Why MassDOT is Wrong  
About the  
Casey Overpass Project  
and  
How it Has Misled the  
Politicians and the Public

By Bridging Forest Hills  
February 22, 2013

## VIEW #2: ILLEGITIMATE COMPARISON

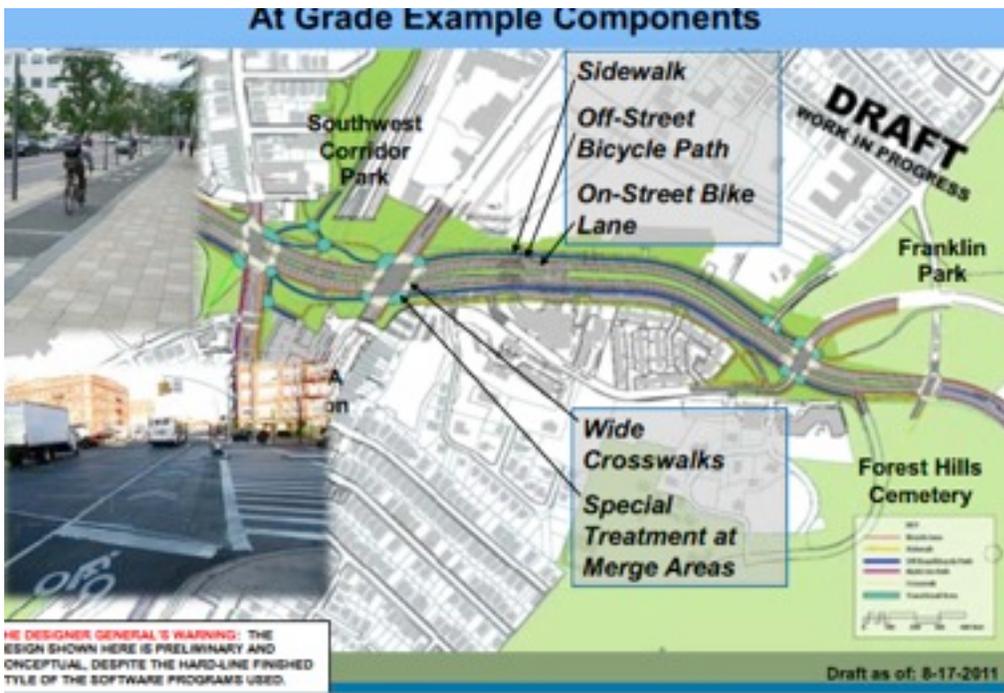
View No. 2 is an illegitimate comparison rendering because:

- The actual three lanes of the at-grade plan (on the left above) are shown to be of the same width as the two lanes of the bridge plan;
- The width of the three lanes for the west bound at grade plan are minimized; and,
- Most significantly, the rendering of the bridge plan stresses through the use of the dark brown and black colors a close similarity to the much larger size, scope and

length of existing Casey Overpass, which is not the case of the actual bridge plan, while the at-grade rendering does not even begin to suggest the reality of the six lanes on the ground that will be necessary under the at-grade plan to accommodate the 24,000 east-west and the 12-14,000 north-south vehicle trips per day.

**VIEW #5: STRONG BIAS**

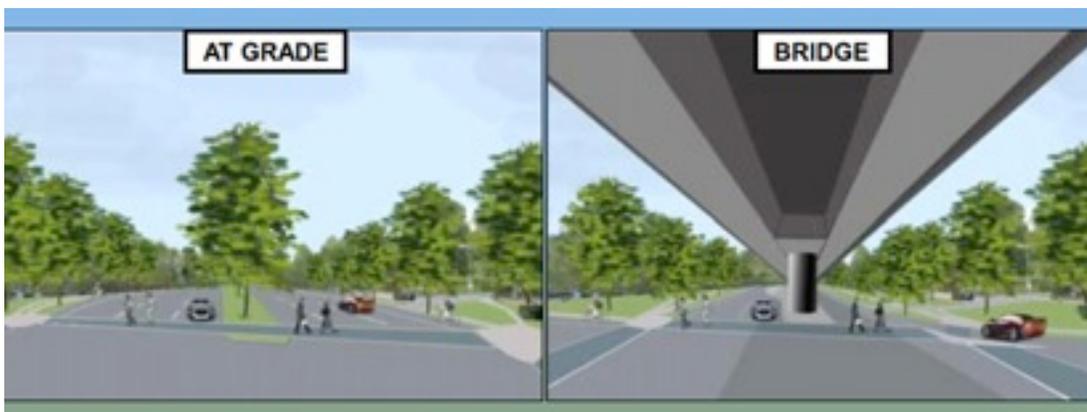
At the public meeting on November 21, 2011, MassDOT, presented to the public once again the above referred to View 2 and View 3 and presented the following additional renderings, each of which shows the strong bias of MassDOT in favor of an at-grade plan.

The size, scope and breadth of the six at-grade traffic lanes are de-emphasized and the proposed bridge (to carry only one lane each way) is made to appear as large as, if not larger than the existing Casey Overpass. Moreover, the one point perspective view would lead the viewer to conclude that the new bridge (actually only one lane each way) would be as wide as the six lanes of asphalt of the at-grade plan. Note also the larger size of the red car in the foreground of the bridge rendering and the smaller size of the red car in the at-grade rendering.
